Introduction

Mechanical Differences Between M30 and M35 Antenna Design

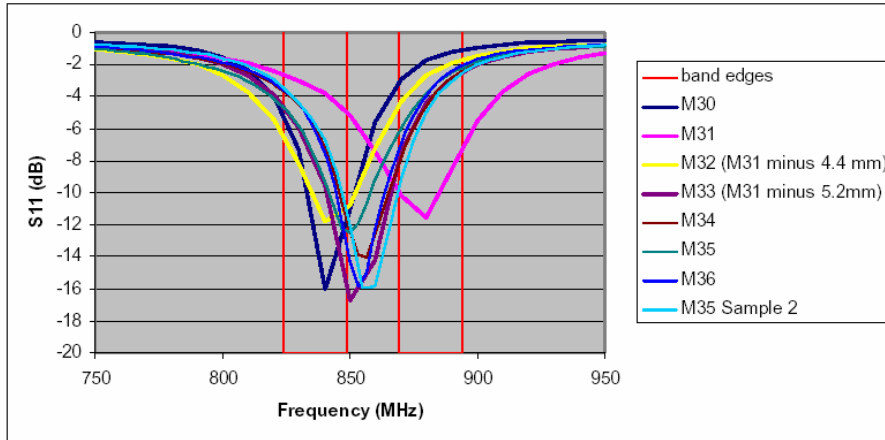
Pictured below is the M30 (left) and M35 (right) antenna. The only difference is the addition of 1.4 mm of material to the vertical slot below. This affects the GSM 850 response only.

GSM 850 Tuning Change

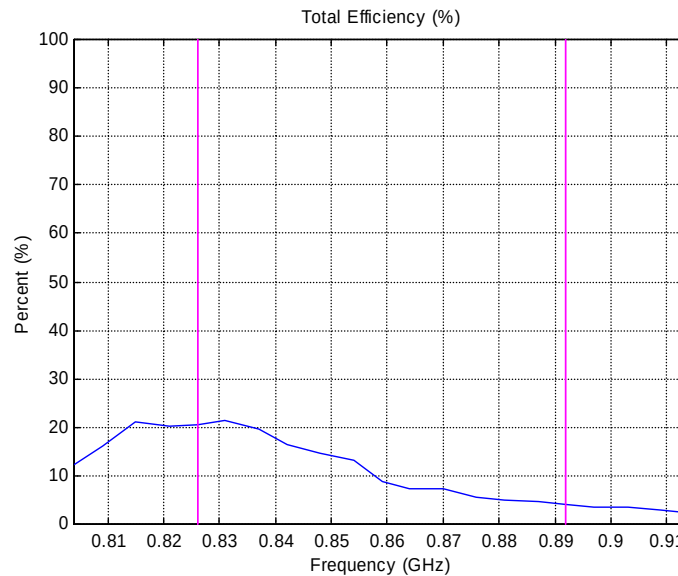
The following shows the difference in tuning for the M30 and M35 antenna. This data is direct from the antenna vendor.

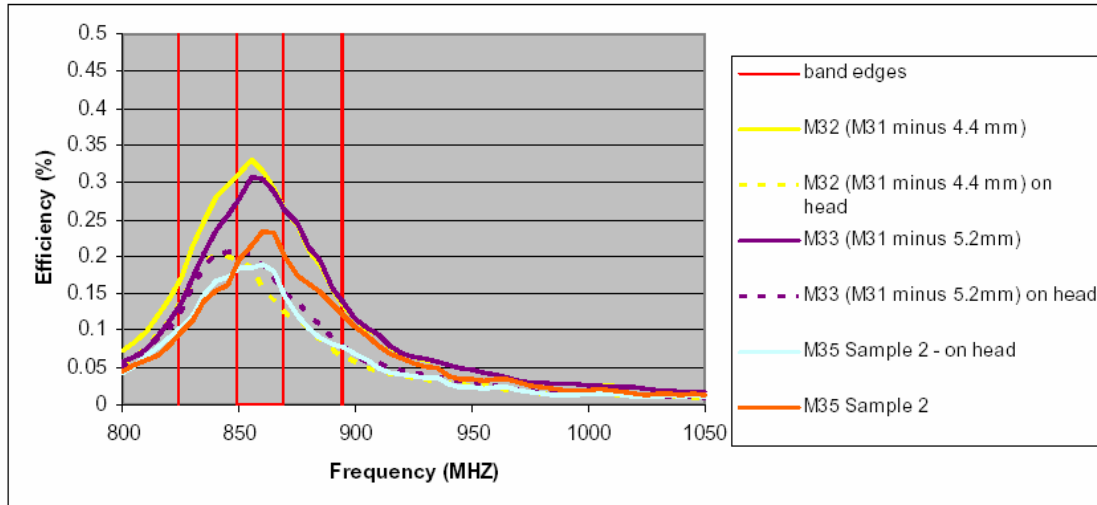
Pictured below is the M30 with the mistuned response. The graph shows overall efficiency.
